PCD FILE NO. PPR-2225

KUM & GO GAS & C-STORE

2232 - EL PASO, COLORADO
SECURITY BLVD. AND MAIN ST.
DETAILED GRADING PLAN - NORTH

2232 - EL PASO, COLORADO
SECURITY BLVD. AND MAIN ST.
EROSION AND STORMWATER CONTROL PLAN - INITIAL

SHEET NUMBER:
C3.8
16 OF 36

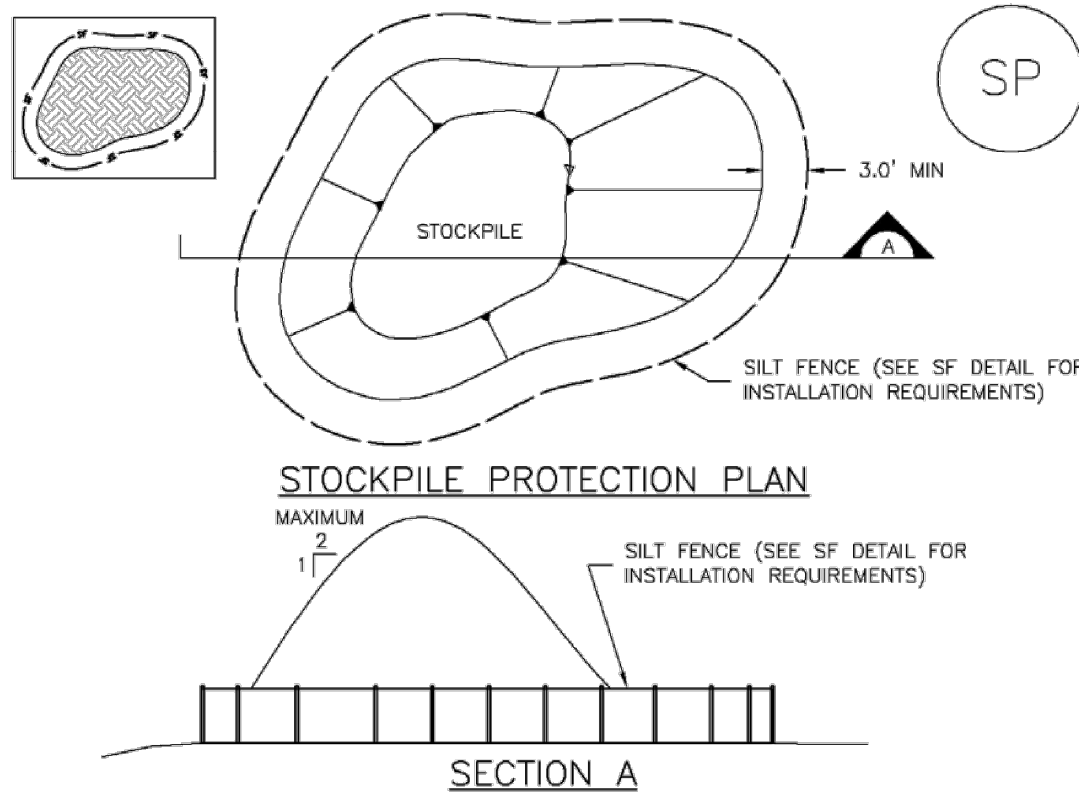
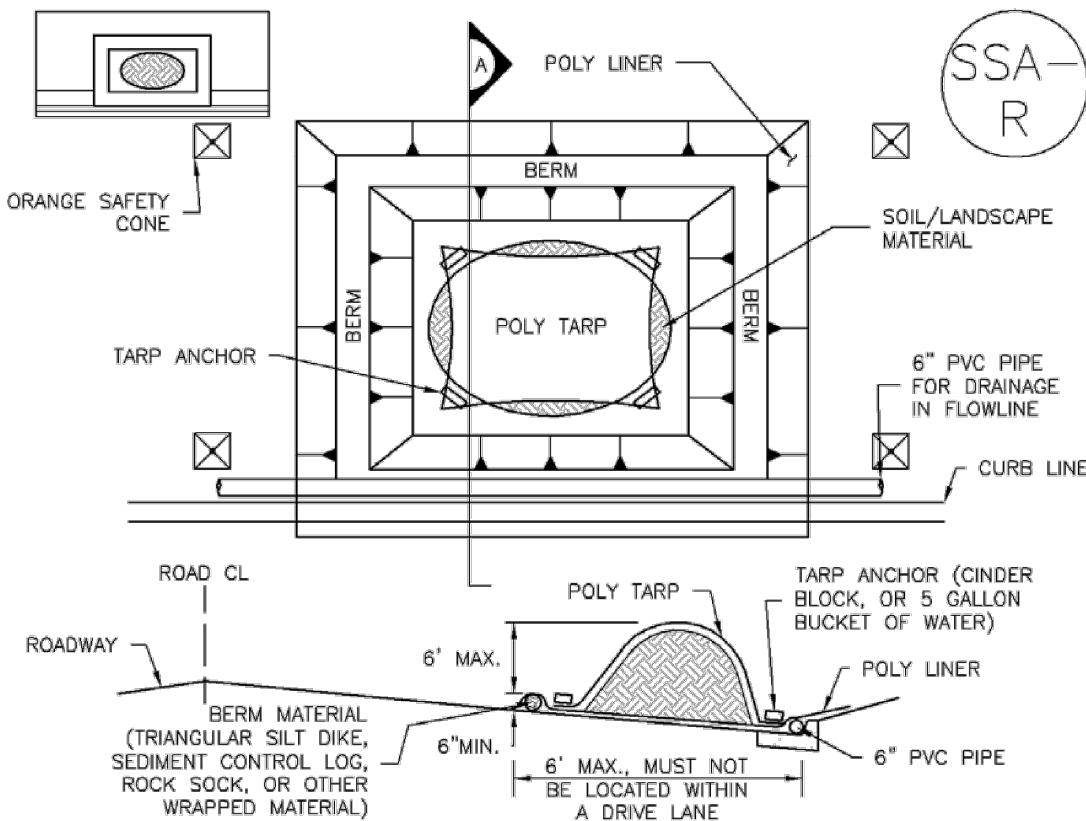
Please remove pdf pages 12-15 from this document. No need to duplicate those here when they are in the SDP doc. Pages 1-11 above are all that is needed for this separate GEC Plan doc.
